T10/05-138r1 SAS-1.1 Proposed Compact Multi-lane Connector Pinouts

To: T10 Technical Committee  
From: Barry Olawsky, HP (barry.olawsky@hp.com)  
Date: 09 May 2005  
Subject: T10/05-138r1 SAS-1.1 Proposed Compact Multi-lane Connector Pinouts

**Compact Multi-lane Connector**

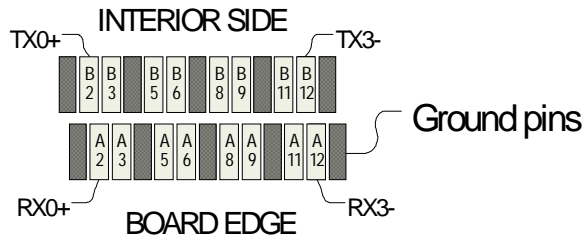
Modify table 29 to reflect the following pinout.

**External to External 26pin Cable based on the Internal pinout  
ALL EXTERNAL DEVICES HAVE THE SAME PINOUT.**

External cable assembly  
(Requires no crossing of pin-to-pin wiring routes)

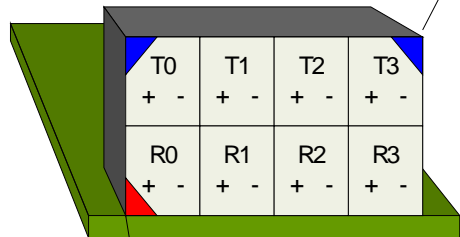
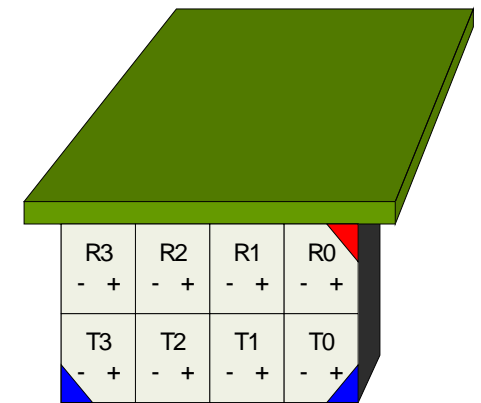
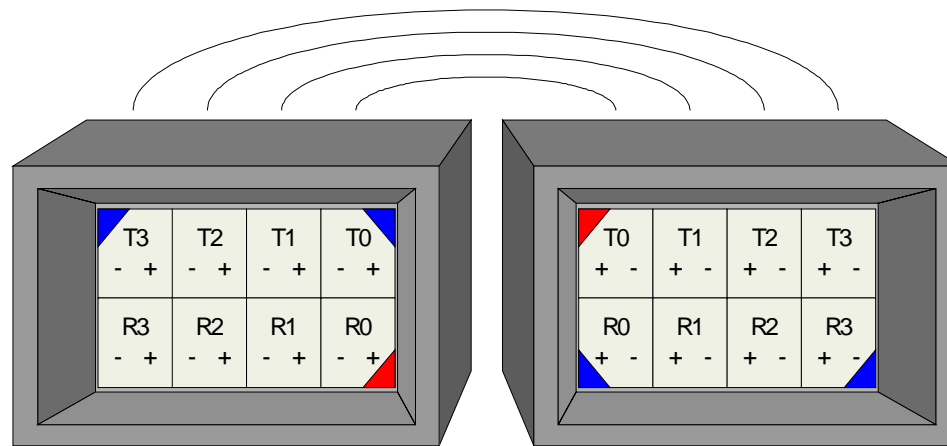
The following text is provided as a visual aid and SHALL NOT be incorporated in the specification.
